16<sup>th</sup> September 2015

**Objections to Applications P/15/066, P/15/067, P/15/068 (Men-a-Vaur site) and P/15/060 Tregarthens Hotel.**

PART OF SITE - OBTAINED FROM THE SOLICITOR OF ONE OF THE RESIDENTS IN RAMS VALLEY  
CONFIRMS NO RIGHTS OF ACCESS FROM APPLICATION SITE TO RAMS VALLEY 13/09/2015

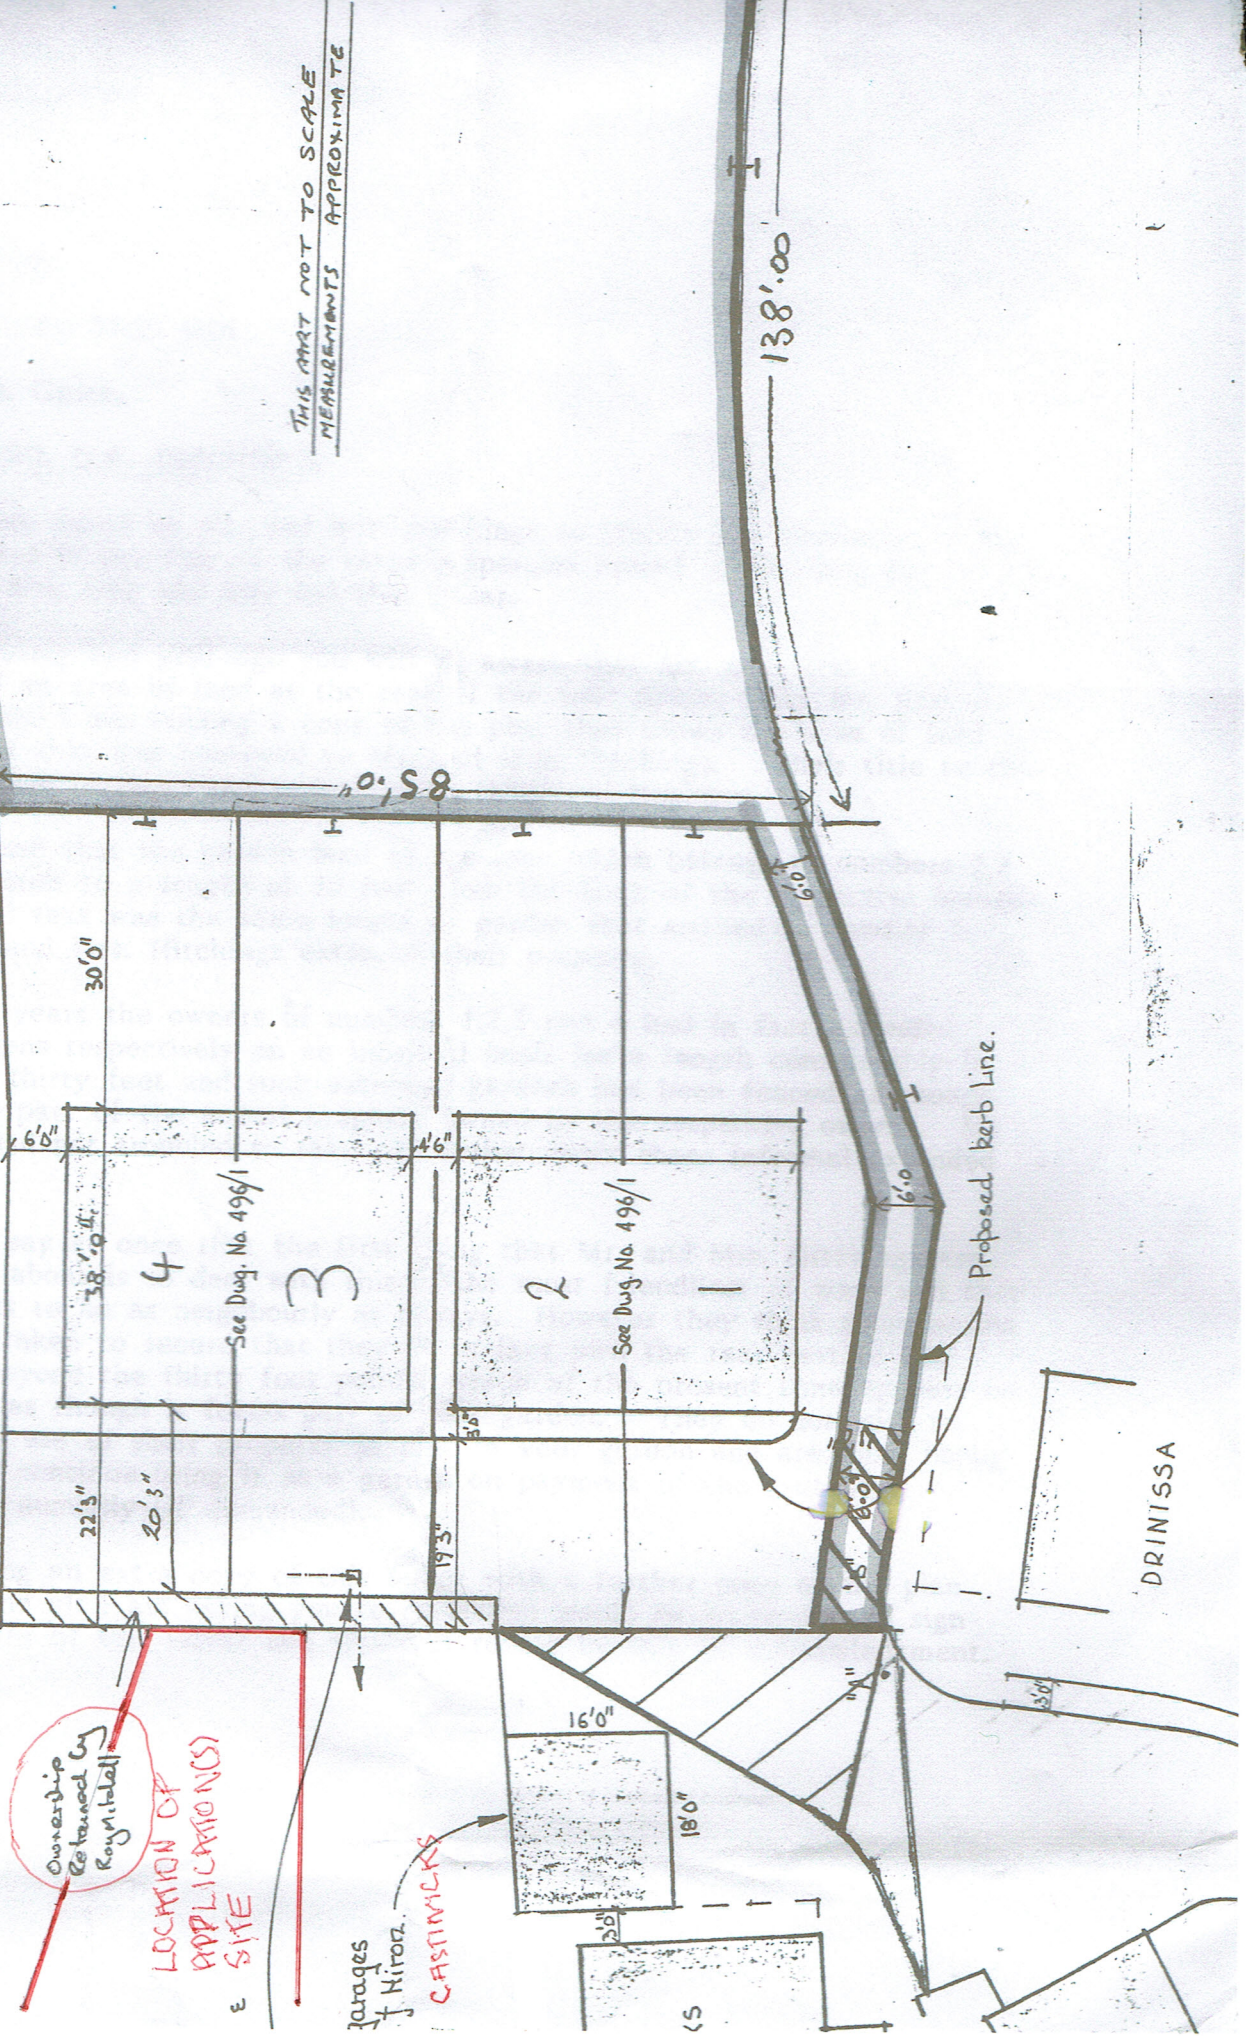
Lest it is believed that Access can be gained from Rams Valley, I attach Sketch 3 confirming that there is no right of access from the Application site to Rams Valley. In fact there remains a low stone wall set back 2 feet from the road kerb (and can be seen behind the foliage) which is the actual site boundary meaning that (for the record) the site area is reduced by c.4 sq.m.
